MEMORANDUM

TO: Landmarks Board

SUBJECT: Public hearing and consideration of a Landmark Alteration Certificate to demolish a non-contributing garage (constructed in 1952), and in its place construct a new 728 sq. ft. two-car garage at 541 Marine St. in the Highland Lawn Historic District per Section 9-11-18 of the Boulder Revised Code (HIS2016-00213).

Figure 7. North Elevation

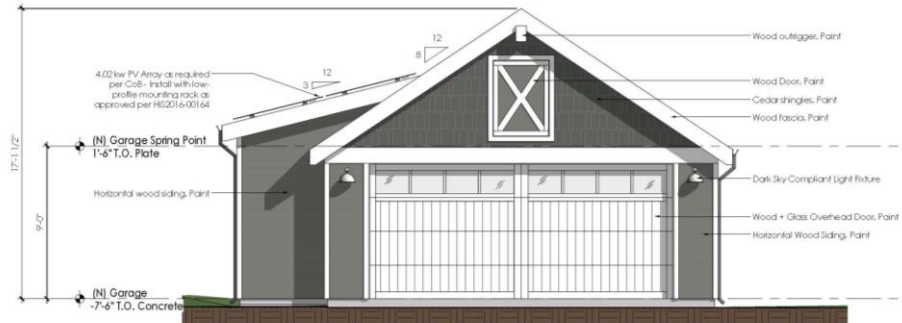
Plans show the proposed two car garage to face onto the alley and to have a front gable form with a shed roof portion at the east elevation. The proposed building is shown to have a footprint of roughly 27' by 27' in dimension, 17' in height and to be clad in horizontal wood siding with shingles in the gable end. A wood door with a cross pattern is located in the gable end, with a wood outrigger above. The garage doors are shown to be wood, overhead doors with four lights at the top of each door. Light fixtures flank the door opening. The wood siding is shown to be painted green and the roof material is shown to be asphalt shingles.

Staff considers the submitted design for a new garage on the property inappropriate. In particular, the large mass, low pitch roof and horizontal form of the building is incompatible with the modest, vertical mass of the historic house. If the applicant choses to move forward with new construction as opposed to rehabilitation of the existing accessory building, staff considers that its size should be reduced to approximately 400 sq. ft., that its form be more vertical in mass and that it be designed with a roof and simple architectural vocabulary more in keeping with the character of the historic house. Staff considers that revisions that keep to these design recommendations may be reviewed and approved by the Landmarks design review committee.

2. Prior to a building permit application, the applicant shall submit, subject to the final review and approval of the Landmarks design review committee, architectural plans for a two car garage of about 400 sq. ft. with a vertical mass and roof pitch/configuration complimentary to the historic house and;

3. Architectural plans indicating exterior materials for the garage more in keeping with the design guidelines including one-over one windows, simplified garage doors, and details on roofing, siding, and paving materials. The applicant shall demonstrate that the design details are in compliance with the intent of this approval and the *General Design Guidelines*.

Figure 9. East Elevation

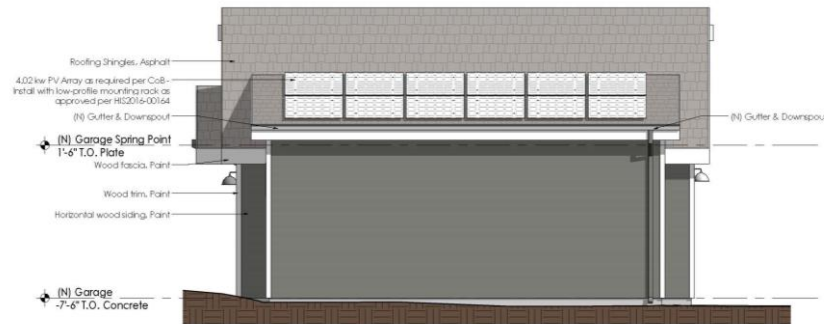
The east elevation is featureless, with the exception of a solar panel system, located on the shed-roof portion of the building. Three windows are shown on the west elevation, each wood with 4-lights.

.7	<i>Roof form and pitch should be complementary to the primary structure.</i>	Roof form is lower in pitch than that of main house. Revise design to more closely reflect the roof of the main house. Resolve at Ldrc.	No
Materials and Detailing			
.8	<i>Accessory structures should be simpler in design and detail than the primary building.</i>	Proposed garage appears to take cues from the approved addition than the historic house. Consider revising and simplifying design including one-over one windows, simpler garage door, and elimination of hay-loft at alley. Resolve at Ldrc.	Maybe
.9	<i>Materials for new garages and accessory structures should be</i>	Materials appear generally in keeping with those on the main	Yes
